One Carrington SSD and Concept Plan (Mod 2)

Attachment B - Response to City of Sydney Submission

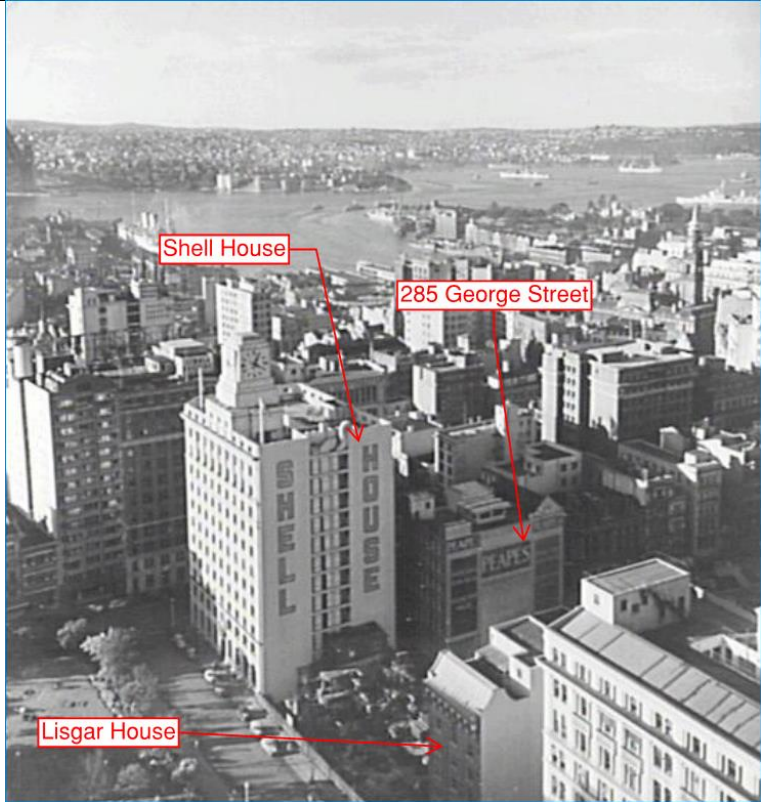
(x) Waterproofing of any exposed surfaces of adjoining buildings.	<p>Brookfield does not support this condition. Brookfield is not aware of a statutory requirement to 'waterproof' an adjoining structure. Each structure, just as it should stand on its own merit from a structural, smoke and fire perspective should also do so from a waterproofing perspective.</p> <p>Notably, Shell House, Lisgar House and 285 George Street are all evidenced (through council's photographic archives – see below) to have been freestanding prior to the Menzies and 301 George Street being constructed and as such should be waterproof in their own right.</p>

Comment	Response
	 <p>Source: Archivepix – File: 028/028320 - http://photosau.com.au/cos/scripts/home.asp</p> <p>Notwithstanding the above, Brookfield (Brookfield Multiplex) shall provide protection to the adjoining buildings in line with industry practice and subject to discussions with the adjoining properties.</p>
(xi) Control of water pollution and leachate and cleaning of vehicles tyres (proposals must be in accordance with the Protection of the Environmental Operations Act 1997).	Noted.
(xii) Working hours, in accordance with this development consent.	Noted.
(xiii) Any Work Cover Authority requirements.	Noted.
(b) The approved work method statements and a waste management plan as required by this condition must be implemented in full during the period of	Noted.
